Subject: Re: Sofidel Pipeline Project- Potential Roost Tree Assessment for Proposed Tree Clearing Areas

Reference: Sofidel Pipeline Bat Habitat Assessment, TAILS #03E15000-2016-TA-0393

Case No(s). 16-0079-GA-BLN

Summary: Exhibit C (Part 1) to Correspondence regarding engineering adjustment electronically filed by Cheryl A MacDonald on behalf of Columbia Gas of Ohio, Inc.

Figure No.
2
Title
Bat Habitat Assessment

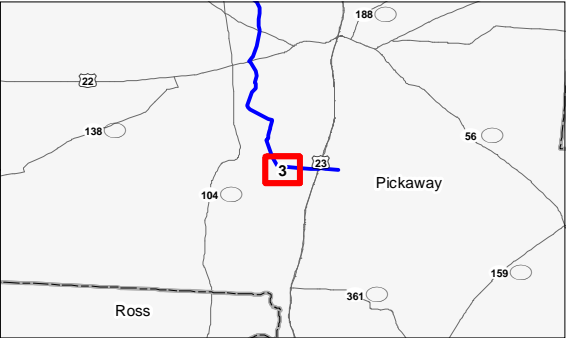
I have no objection to clearing these 10 trees at any time of the year. I do not anticipate impacts to Indiana bats or northern long-eared bats from the cutting of these 10 trees.
